CORRIGENDUM – 1

Tender Reference Number	302/52/2020- NFHM
Tender Title	Request for Proposal for Selection of Master System Integrator (MSI) for implementation of NFAI's Data Center and Enterprise Solution (NES)
Tender Publishing Date	16 December 2020
Corrigendum Published based on	Clarifications to the RFP

4. Chapter 2, Section 15.7.5.3, Network Architecture, and Under Chapter 6, Section 1, Technical Requirements, the following changes have been made

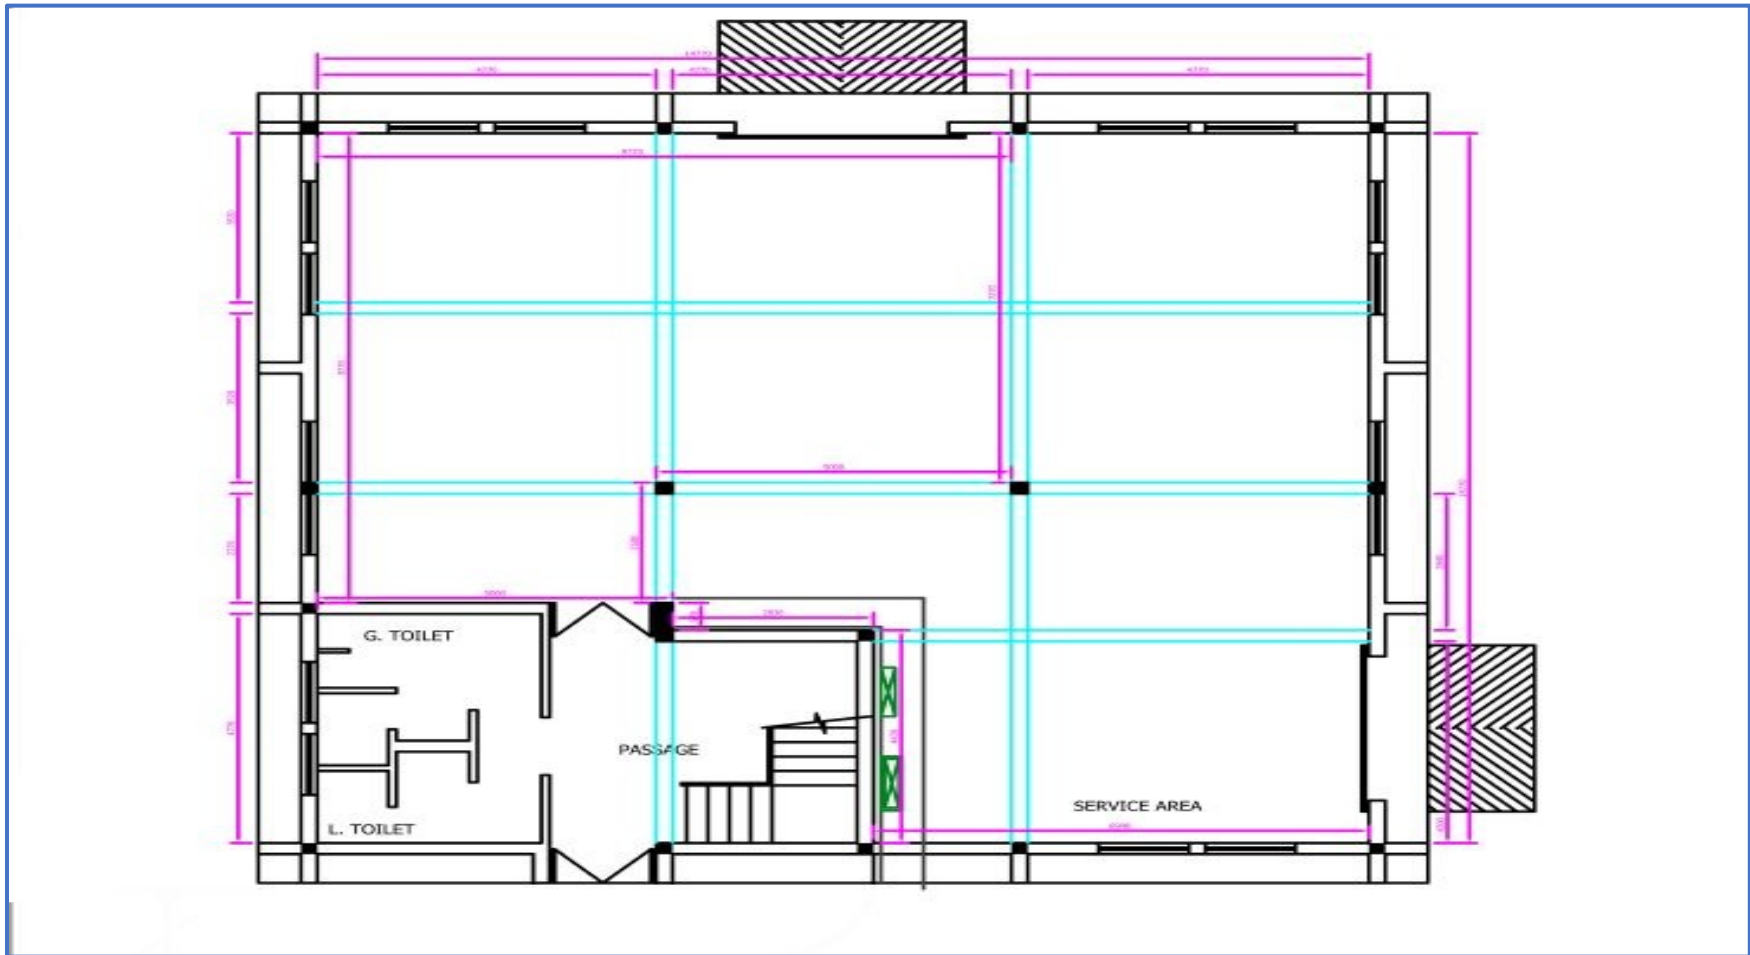
12	2.Scope of work	15.7.5.4.	Data Center/ Disaster Recovery (DC/ DR) Services	133	Schematic diagram - Paste (Page 63)	Refer Section 4 of Annexure in Corrigendum- 1
13	6. Annexure	Figure	Data Center/ Disaster Recovery (DC/ DR) Services	135	NFAI Data Center Reference Architecture (Page 133)	Refer Section 4 of Annexure in Corrigendum- 1
14	2. Scope of work	5.3.	LTO Library and Maintenance		5.3.3. MSI should be responsible for hardware upgradation.	This clause stands deleted
